CITY OF SAINT PAUL
HERITAGE PRESERVATION COMMISSION STAFF REPORT

FILE NAME: 1498 Summit Avenue

DATE OF PUBLIC HEARING: November 16, 2020

CLASSIFICATION: New construction

Proposed Site Plan Survey For:

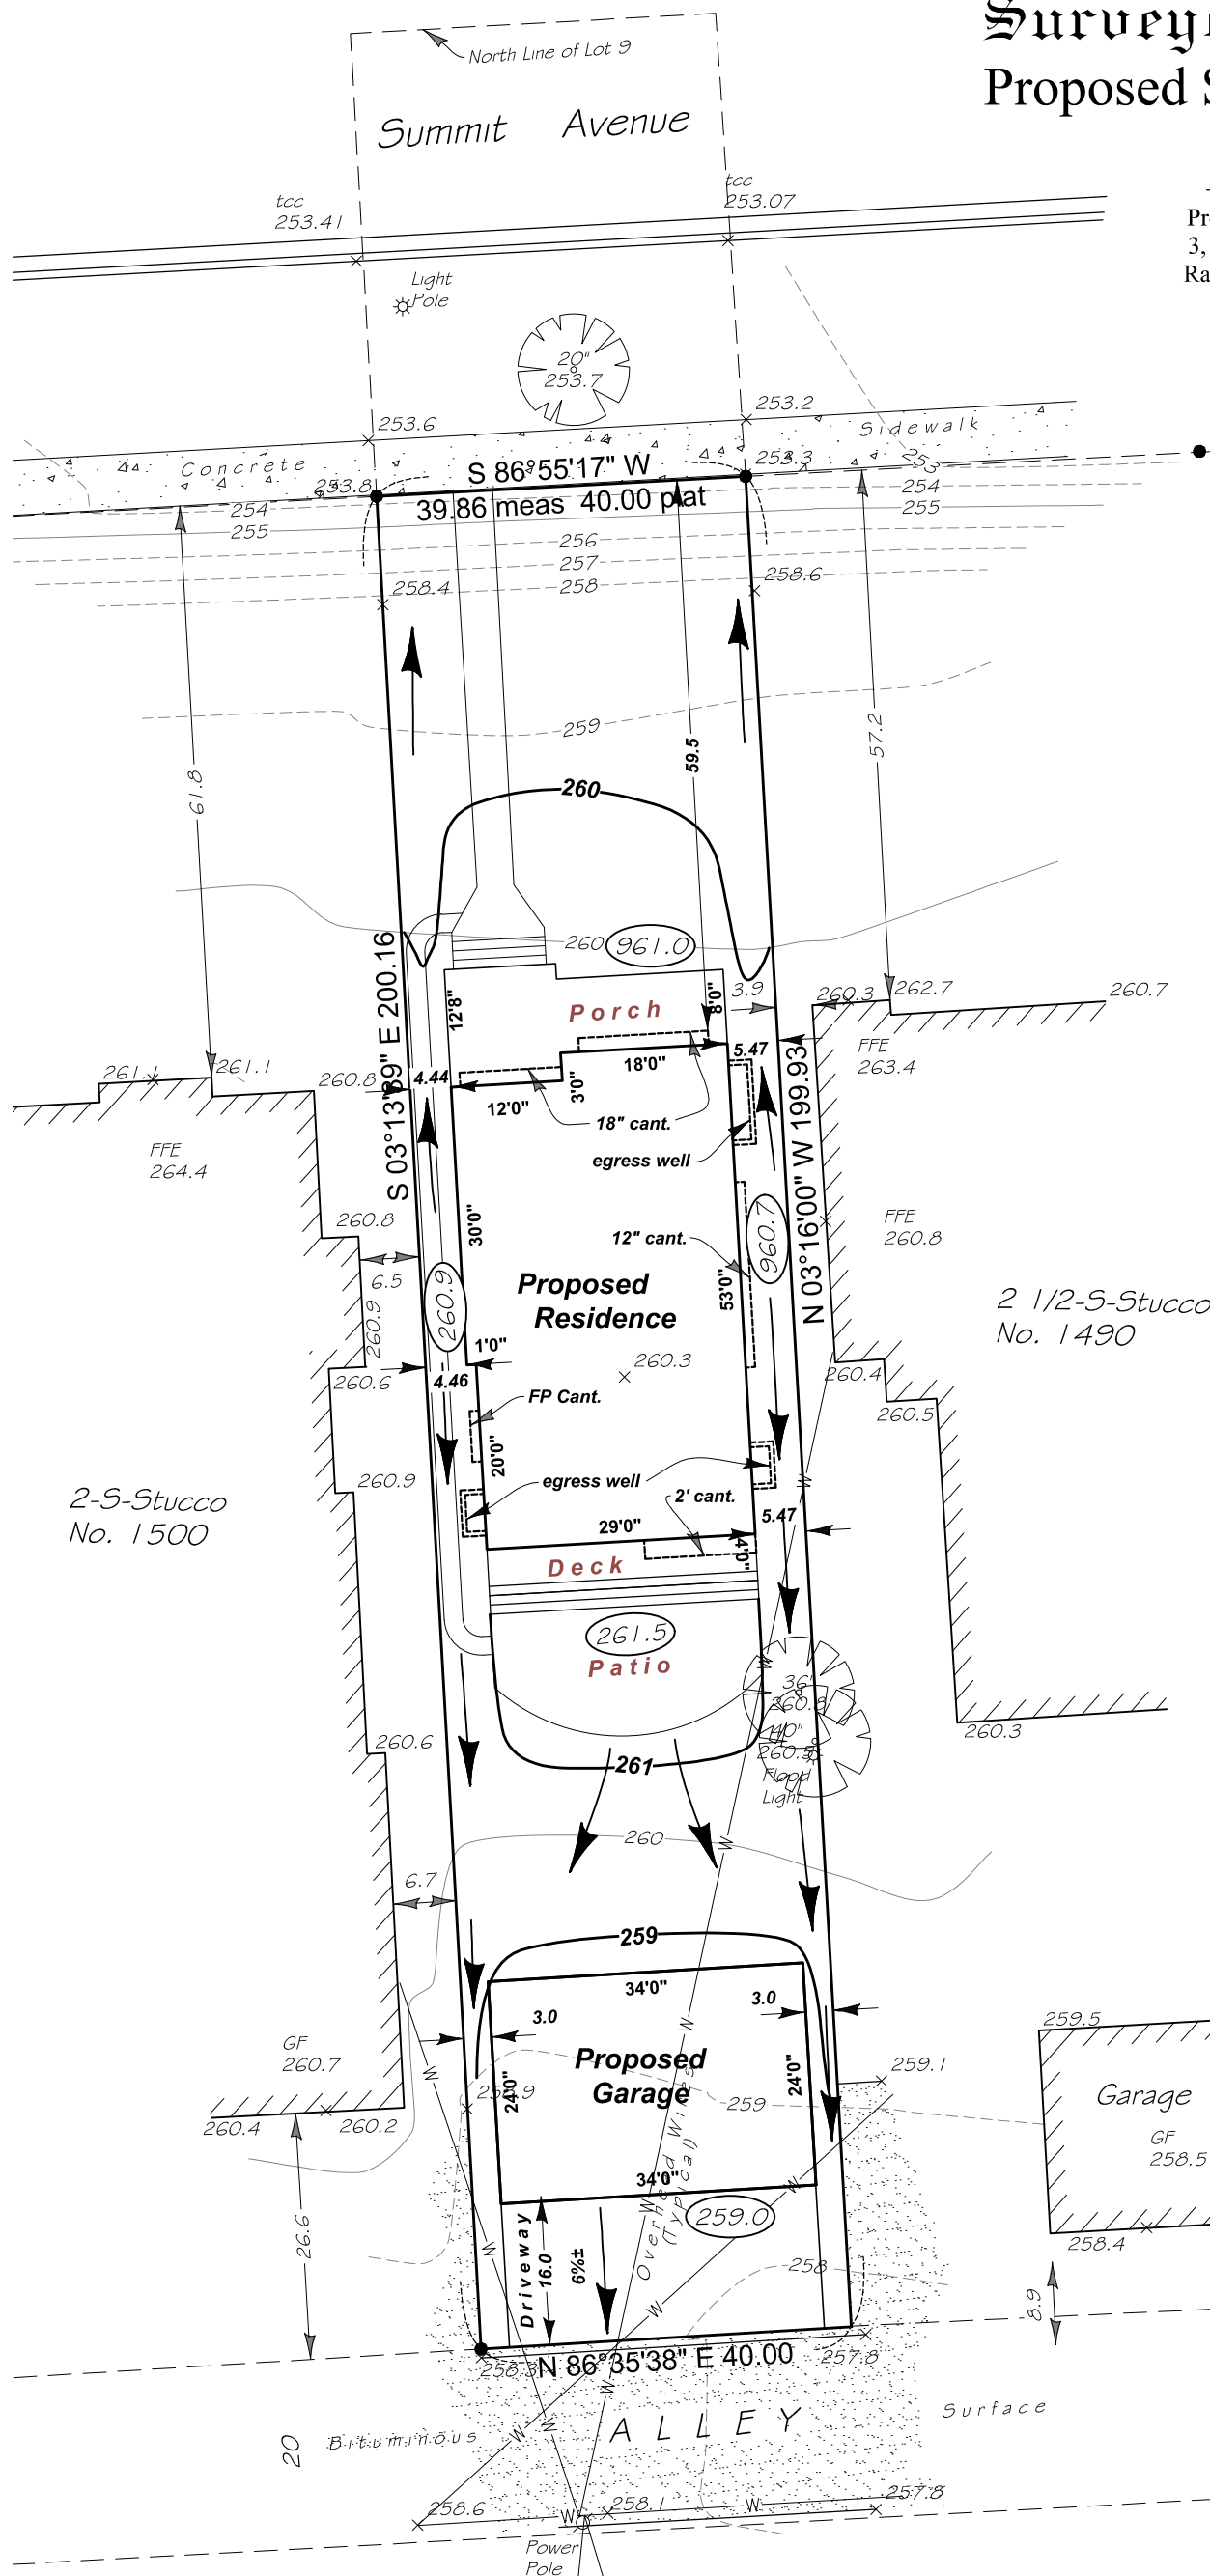
<p>(e)(3) <i>Garages and parking.</i> Parking spaces should not be located in front yards. Residential parking spaces should be located in rear yards. If an alley is adjacent to a dwelling, any new garage should be located off the alley.</p>	Not Determined	Per the site plan, the garage is sited at the alley, however a plan for the garage design was not provided and will need to be submitted for review and approval prior to permit issuance.

1. All final materials, details, and plans shall be submitted to staff for review and approval.
2. Plans for the detached garage shall be submitted to staff for review and approval.
